## LAND USE APPLICATION INFRASTRUCTURE DELIVERY REFERRAL

<b>DA / CC File Number:</b>	DA2021/0082
<b>Referral Details</b> (dd / mm / yyyy)	11/05/2021
<b>Subject:</b>	Proposed Solar Farm
<b>Location:</b>	11498 Newell Highway NARRABRI (Lot 102 DP 579423)
<b>Planning Officer:</b>	Cara Stoltenberg

**DA2021/0082: Lot 102 DP 579423 11498 Newell Highway, Narrabri- Electricity Generating Works (Solar Farm) with a 5.0 MW capacity**

*Australian Disaster Resilience Handbook Collection – Flood Hazard Mapping for 1 in 100 year event.*

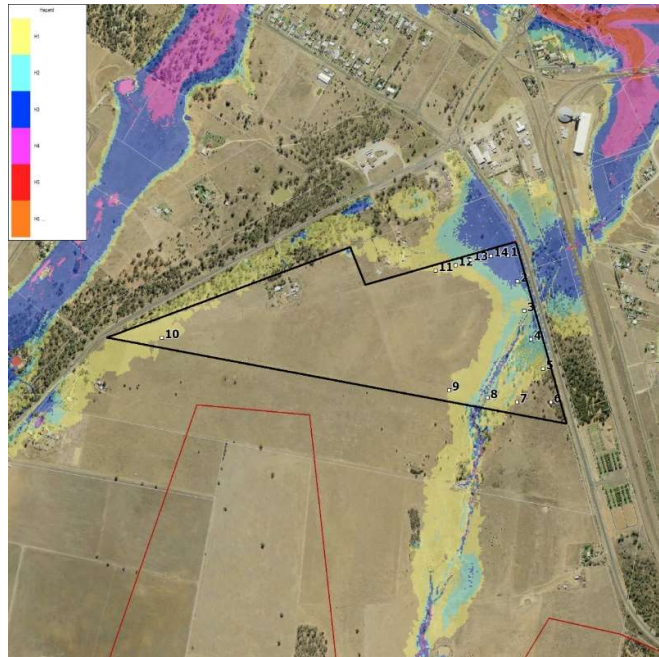
Based on the above information, and the image below, the majority of the subject allotment is not affected by flooding in the 1 in 100 year event. However, there is some minor flooding that occurs on the western corner of the lot which is given a H1 hazard category. The eastern side of the allotment is subject to some flooding in the 1 in 100 year event, which gets deeper toward the northern point. In this eastern side the hazard category ranges from H1 to H2 and H3. This land is considered suitable for the intended purpose of the proposed solar farm. Vehicle access to the site is best determined with regards to the area of the lowest hazard category to allow access and egress to the site during a 1 in 100 year flood event.

It is considered that the proposed solar farm is compatible with the existing flood hazard of the land, and the proposed development will not detrimentally effect the future flood behaviour in the local catchment. To mitigate the impact of the proposed development on flood behavior, the following restrictions are proposed to be included in the conditions of consent;

- the development is to be constructed to allow the free flow of flood water under and around all open structures.
- A condition of consent should also be added to any approval that stipulates that the site is to be kept tidy at all times and no moveable objects are to put on the site without the previous approval of Council.

Figure 8.2: Rural basic left-turn treatment (BAL)

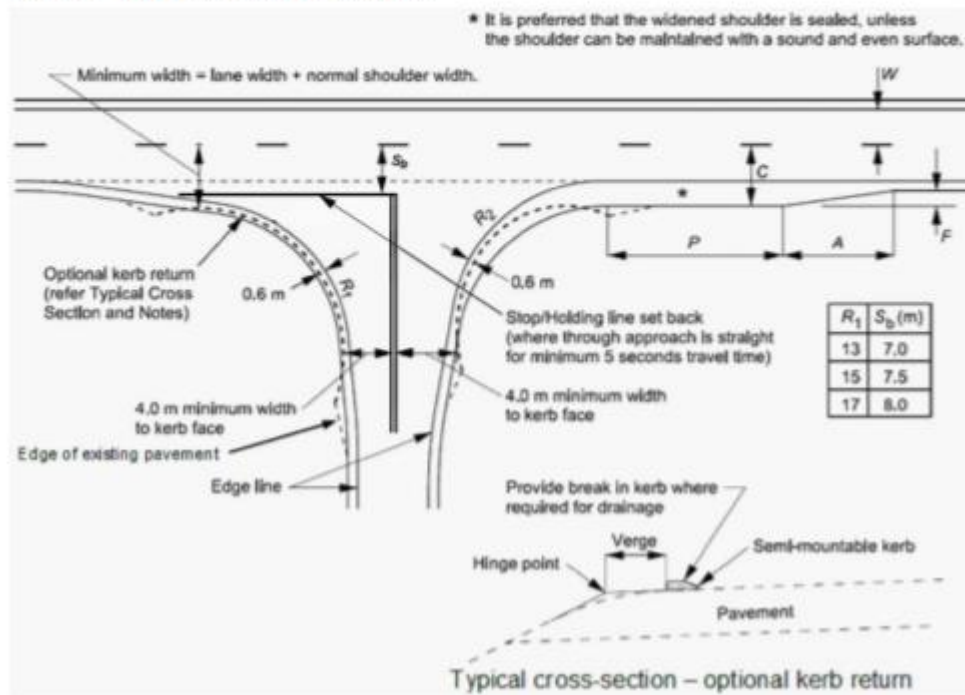
- Prior to commencement of construction the intersection of the western access with the Newell Highway, the access is required to be upgraded to provide a Rural basic left-turn (BAL) in accordance with figure 8.2 (see appendix 1) of Part 4A of *Austroads Guide to Road Design*.
